# Service Bulletin

Bulletin No.: 18-NA-200

**Subject:** Diagnostic Tip for Rattle Type Noise Heard From the Instrument Panel (IP) Area

4421628

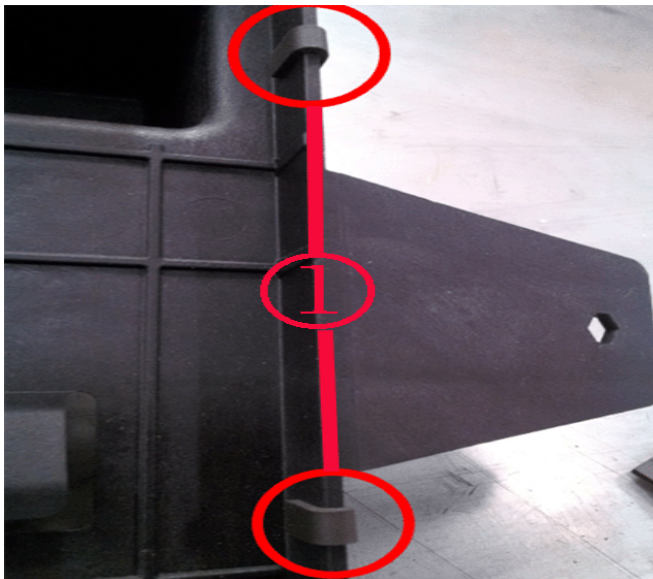
1. The ECM may be loose in the mounting bracket. If you can move the ECM in the bracket remove it from the mount and apply 2 foam strips, 2mm thick, 20mm by 15mm (1) to the body of the bracket and reinstall the ECM. Use 3M 4696 adhesive backed foam or equivalent and place the foam strips, as shown in the photo above.
2. The harness retainer tab on the heater pipes may be contacting the bulkhead. This noise is heard from the center / lower part of the IP usually when in reverse. This can be viewed from underneath the vehicle from the right side looking over the exhaust flex pipe and over the bell housing. The tab can be bent back away from the bulkhead with a pry bar.
3. The air box snorkel rattles on the inner fender. This can be heard at idle or driving. If you press on the wheel liner the noise will stop. Replace the air inlet duct. Refer to Front Intake Air Duct Replacement in SI.
